State of Hawaii
DEPARTMENT OF LAND AND NATURAL RESOURCES
ENGINEERING DIVISION
1151 Punchbowl Street, Room 221
Honolulu, Hawaii 96813

ADDENDUM NO. 2

Job No. F48C612A
Keaiwa Heiau State Recreation Area Water System Improvements
Aiea, Hawaii

May 19, 2026

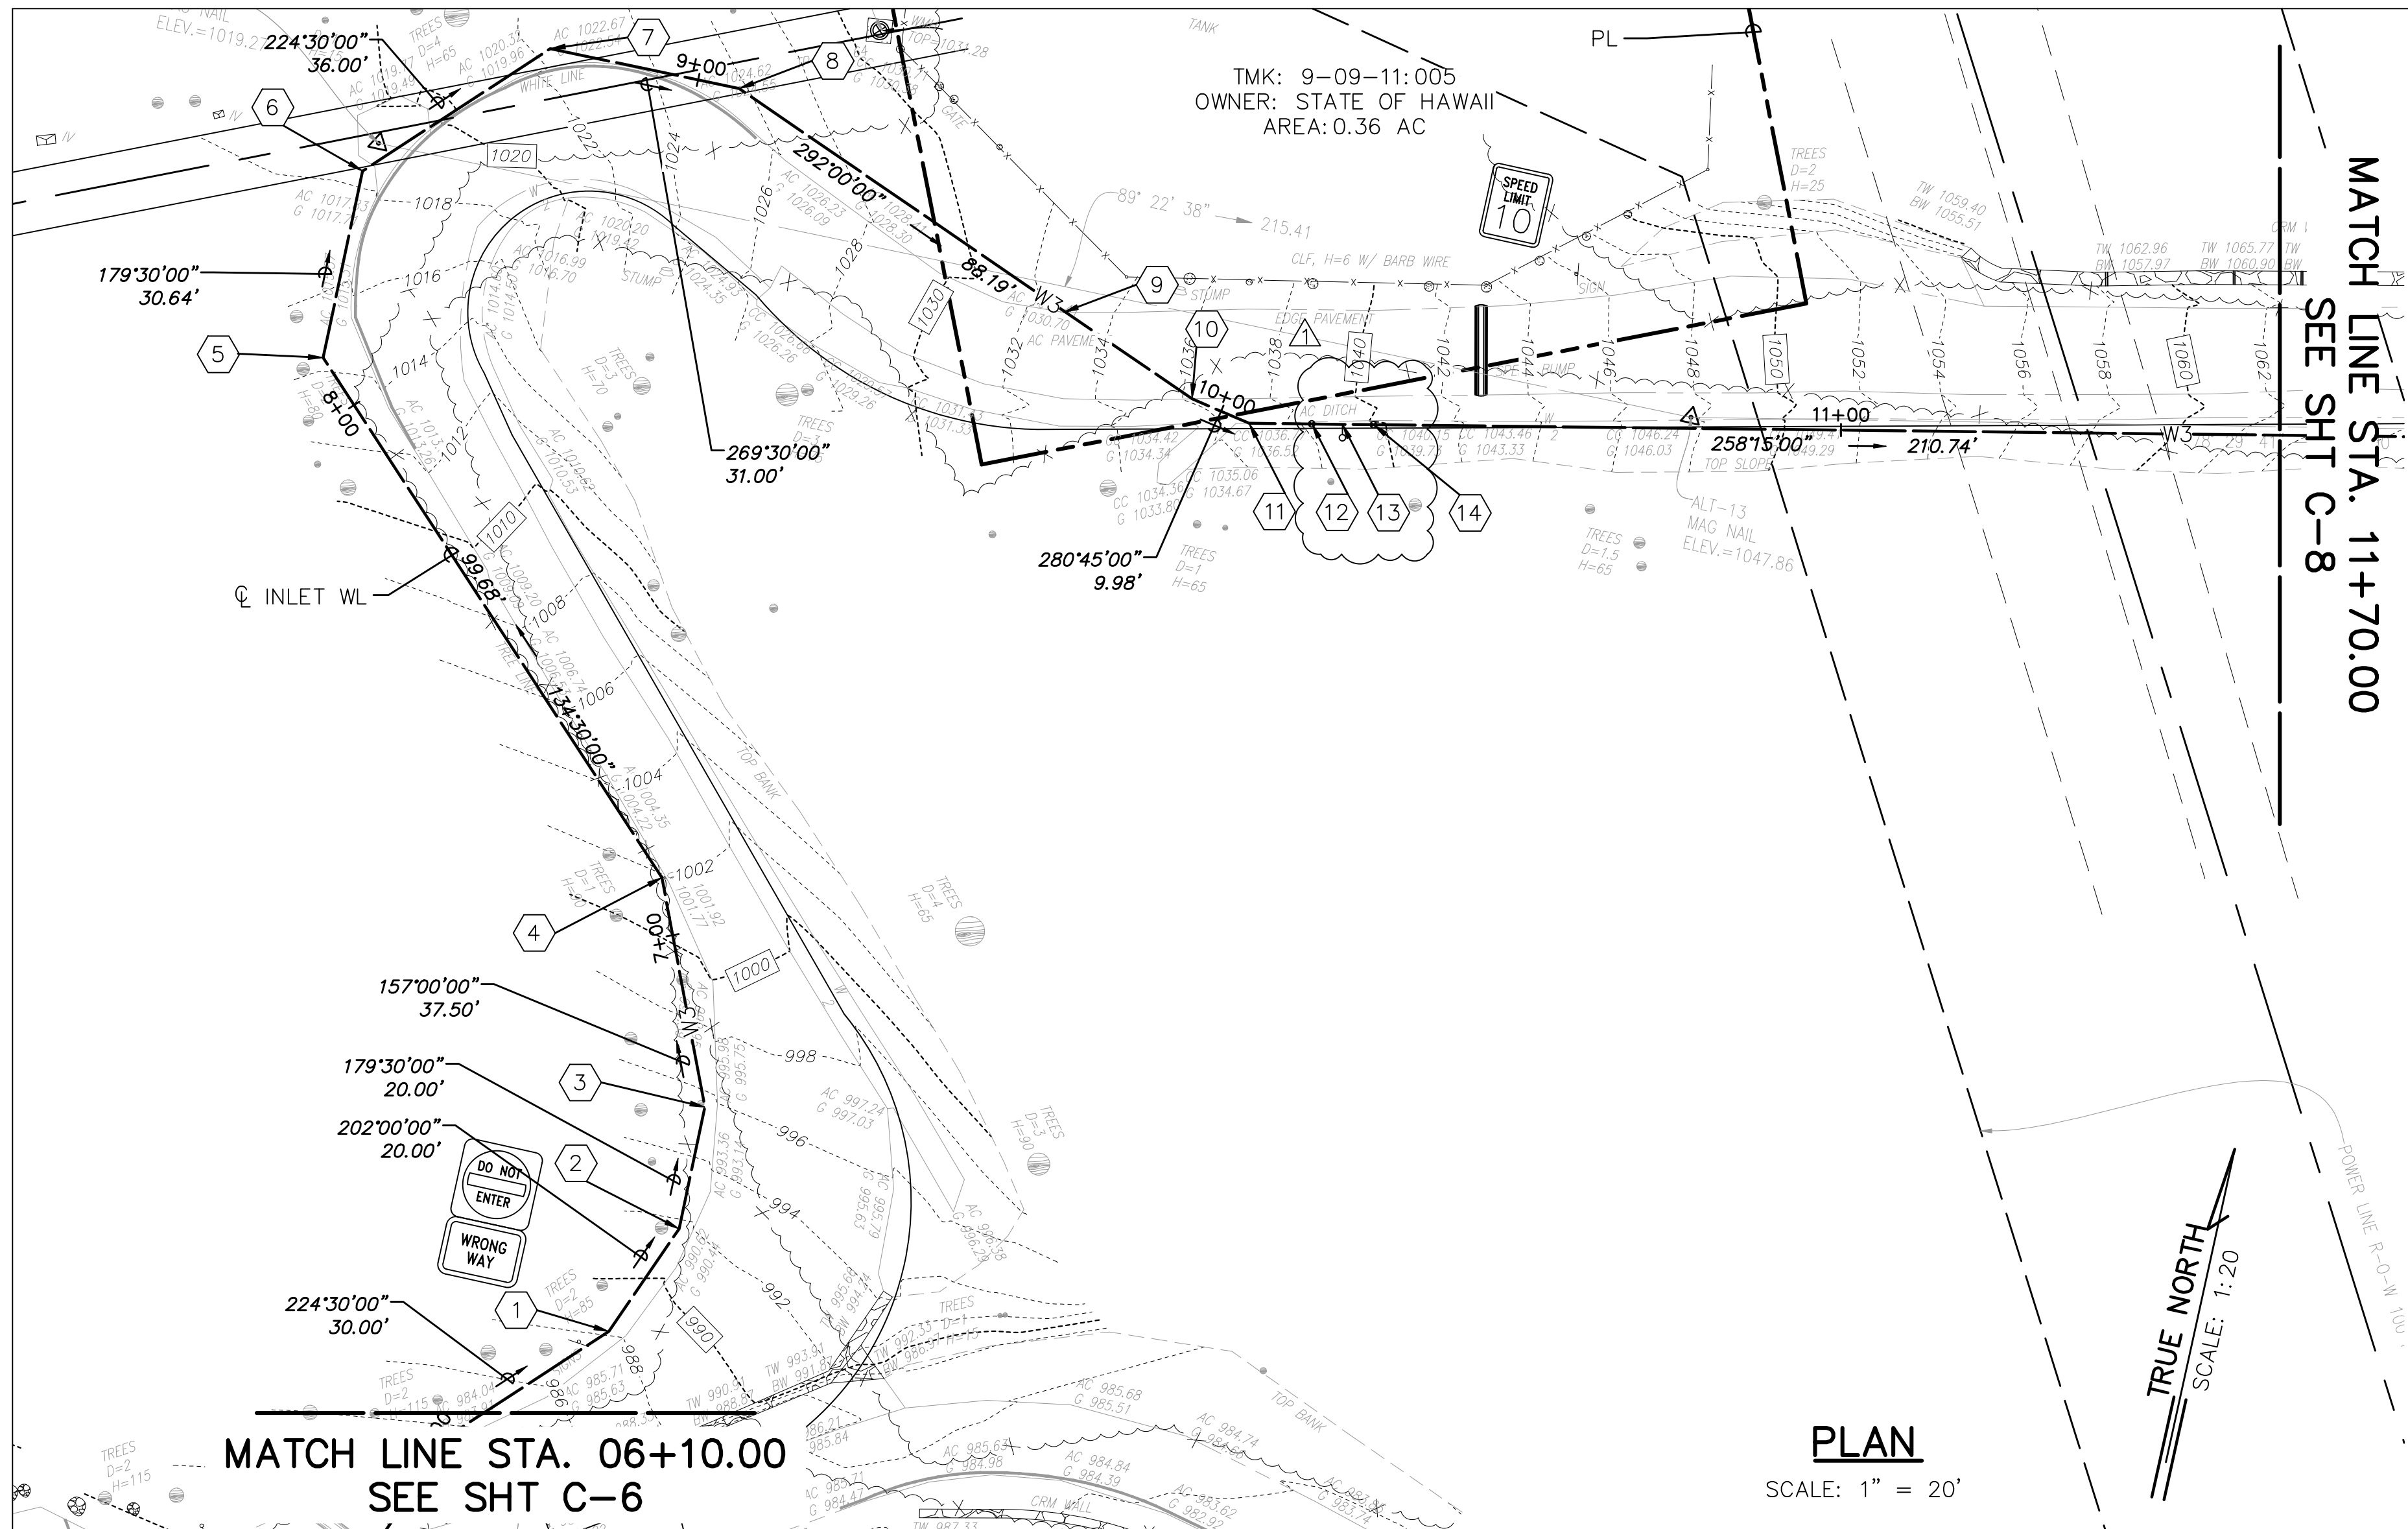
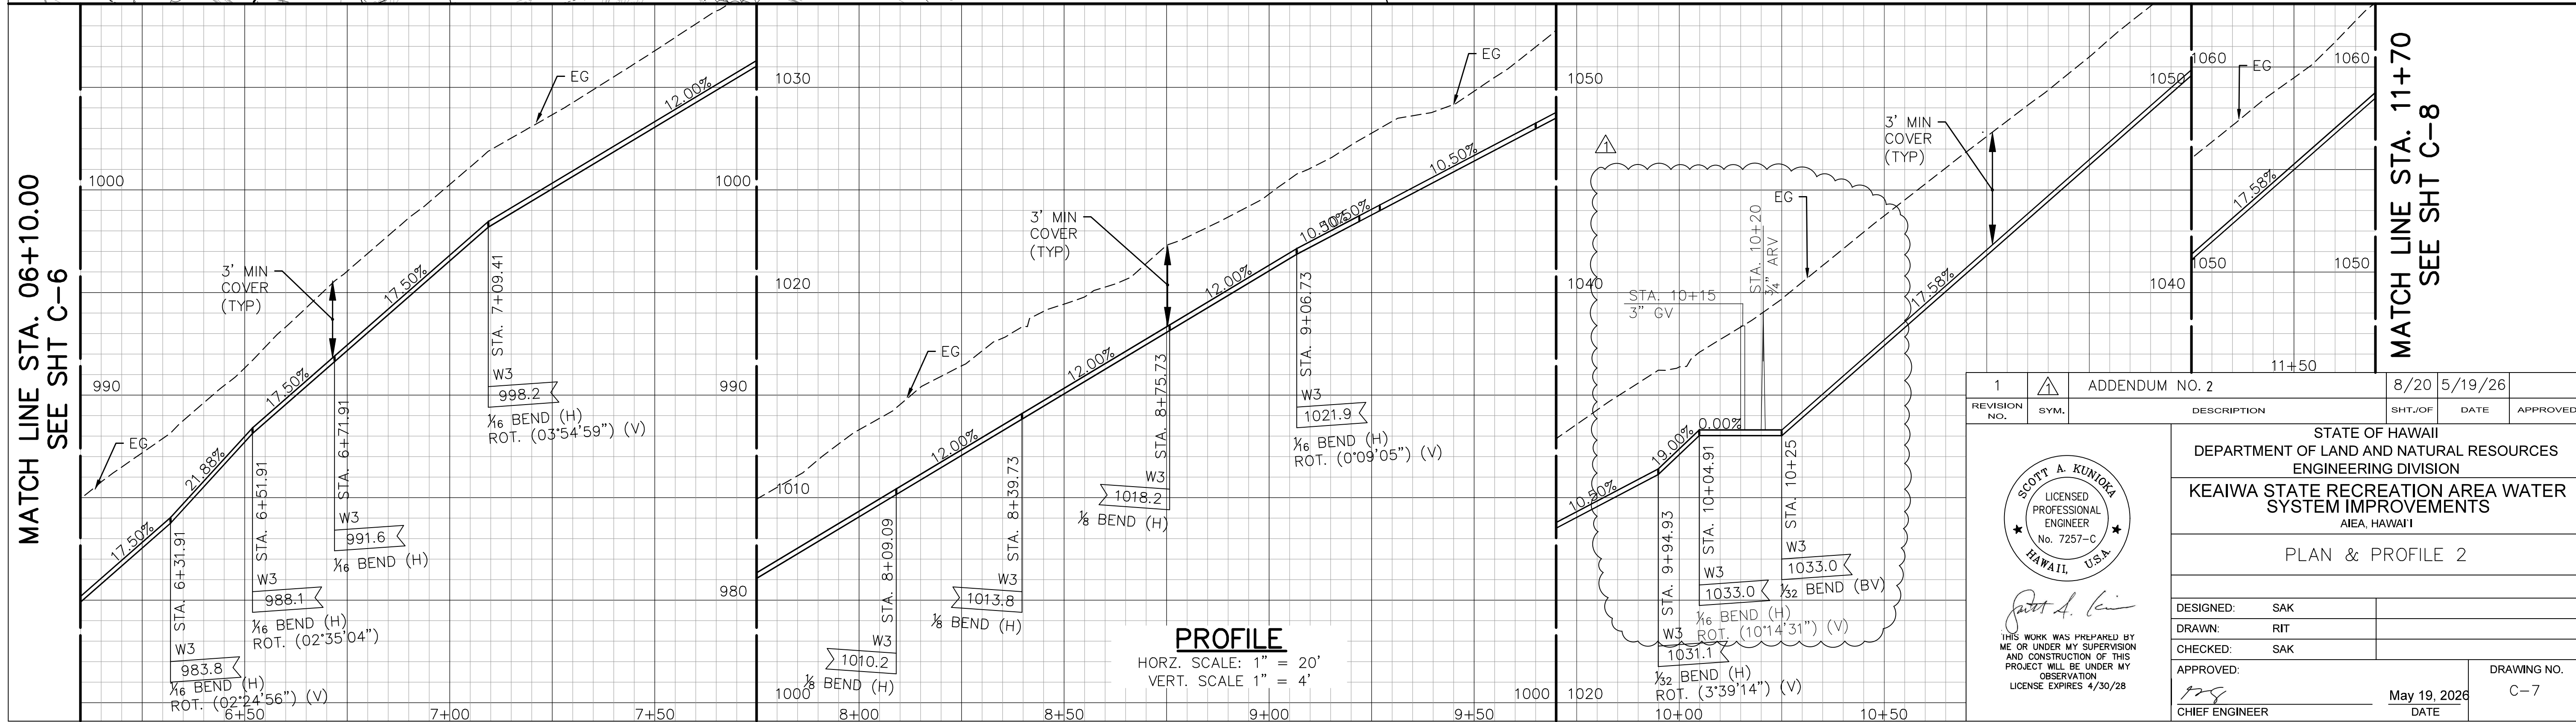
- a. Added new quick coupling valve.
3. Sheet C-7 – Plan & Profile 2, Replace sheet with the attached revised Sheet C-7.
 - a. Added new gate valve and Air relief valve.

1 - 3/4" ARV SEE
SEE WSS STD DET. V2
1 - 3"X3"X3/4" SCH 80 PVC TEE | |
